Economic Commission for Europe
Inland Transport Committee
World Forum for Harmonization of Vehicle Regulations
Working Party on Lighting and Light-Signalling
Seventieth session

Geneva, 21-23 October 2013

Report of the Working Party on Lighting and Light-Signalling on its seventieth session
Contents

"Figure 2.

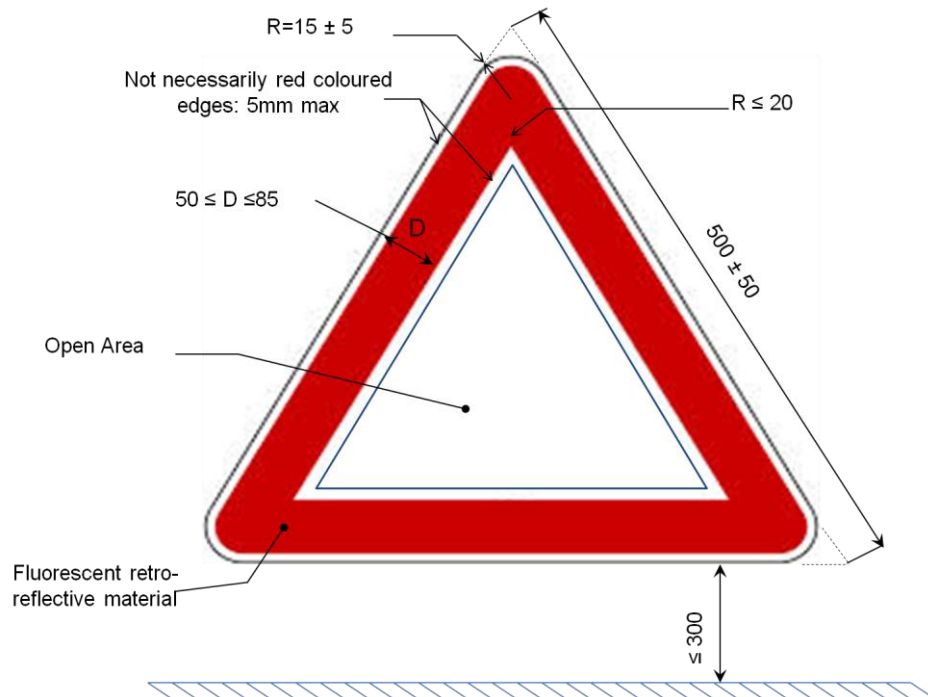
Annex 3, insert a new Figure 2., to read:

Shape and dimensions of the advance-warning triangle of type 2 and of the support

**"Figure 2
 Impedance of HV artificial network**

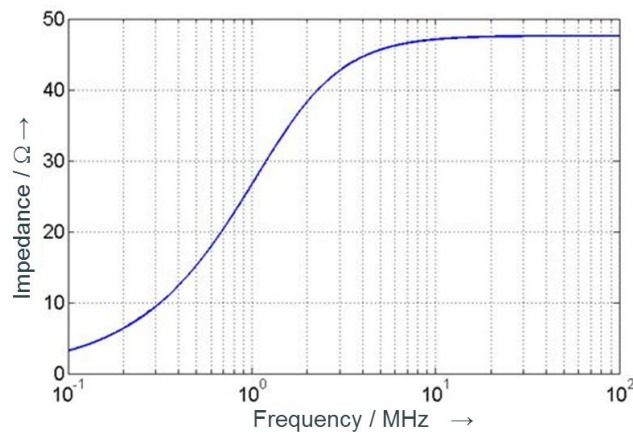
Appendix 8, figure 2, delete and replace by:

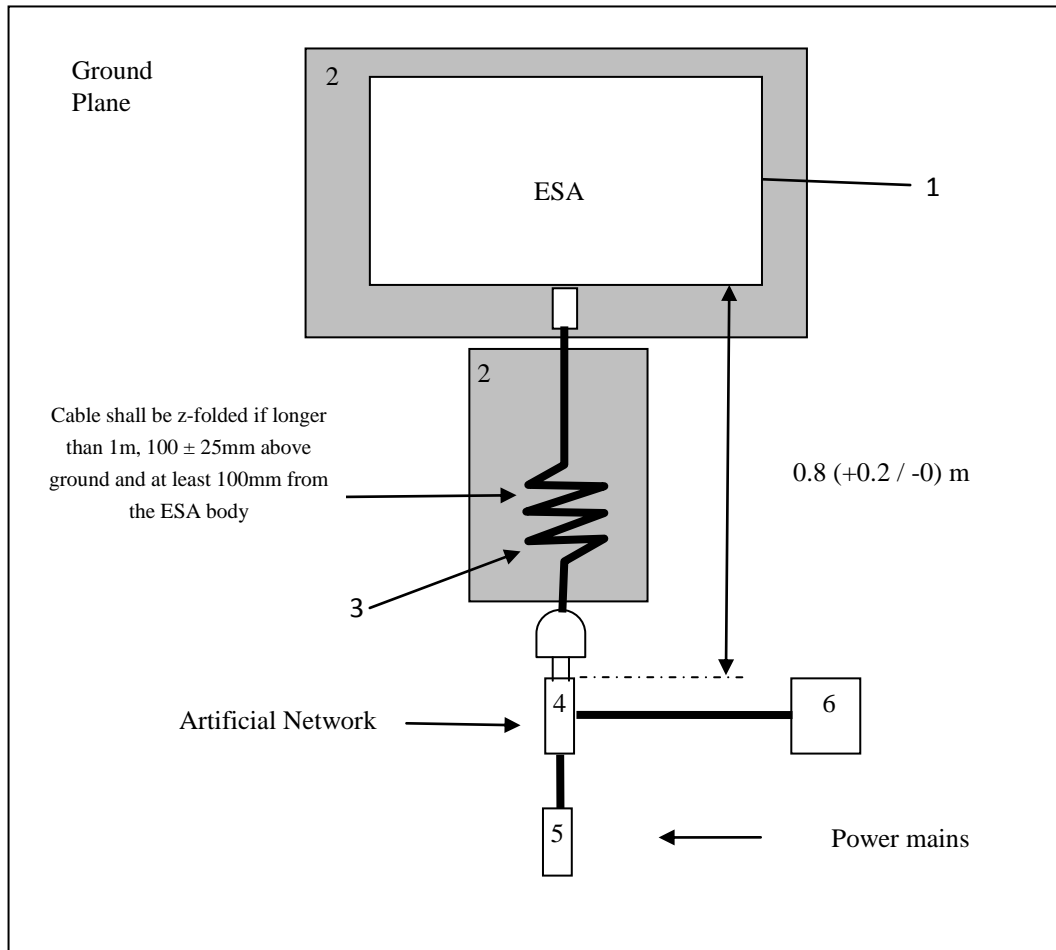
The AN(s) shall be mounted directly on the ground plane. The cases of the AN(s) shall be bonded to the ground plane.

~~The measuring port of each AN shall be terminated with a 50 Ω load.~~

The conducted emissions on AC and DC power lines are measured successively on each power line by connecting the measuring receiver on the measuring port of the related AN, the measuring port of the AN inserted in the other power lines being terminated with a 50 Ω load.

The AN shall be placed in front, aligned and on the same side of the vehicle power charging plug.

"Figure 1
ESA in configuration "REESS charging mode coupled to the power grid"

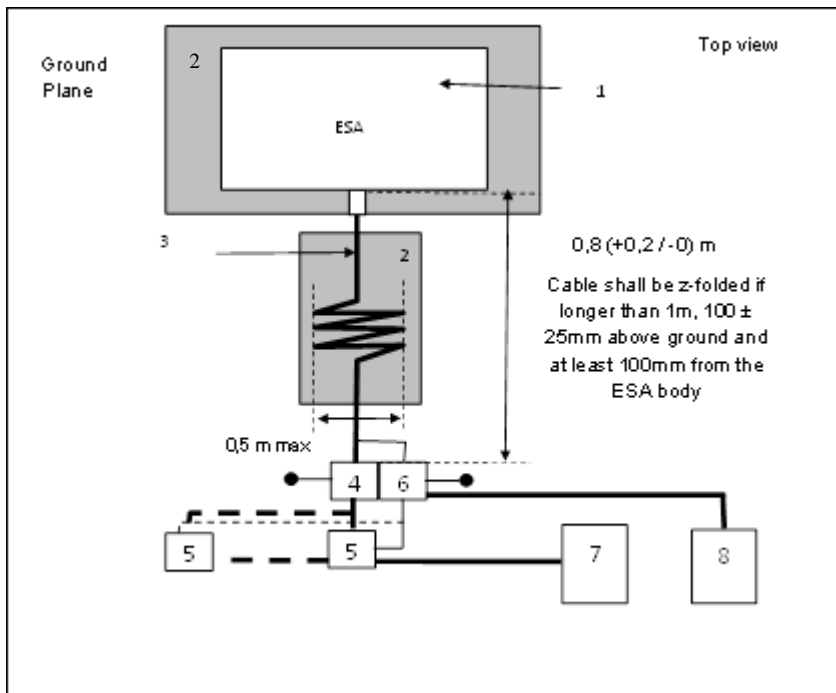
Annex 19, Appendix, Figure 1, delete figure and replace by:

The IS(s) shall be mounted directly on the ground plane. The case of the IS(s) shall be bonded to the ground plane.

~~The measuring port of each IS shall be terminated with a 50 Ω load.~~

The conducted emissions on network and telecommunication lines are measured successively on each line by connecting the measuring receiver on the measuring port of the related IS, the measuring port of the IS inserted in the other lines being terminated with a 50 Ω load.

The IS shall be placed in front, aligned and on the same side of the vehicle power charging plug."

Figure 1
ESA in configuration "REESS charging mode coupled to the power grid" - Coupling between lines for DC or AC (single phase) power lines.

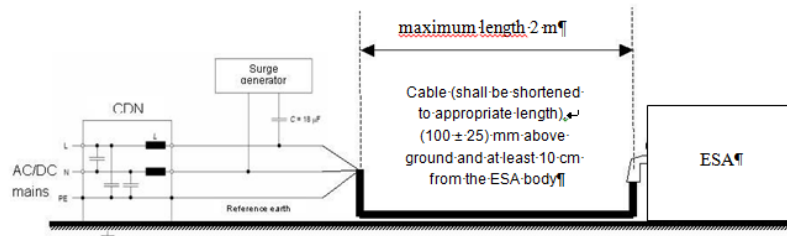
Annex 22, Appendix, Figures 1-4, amend to read:
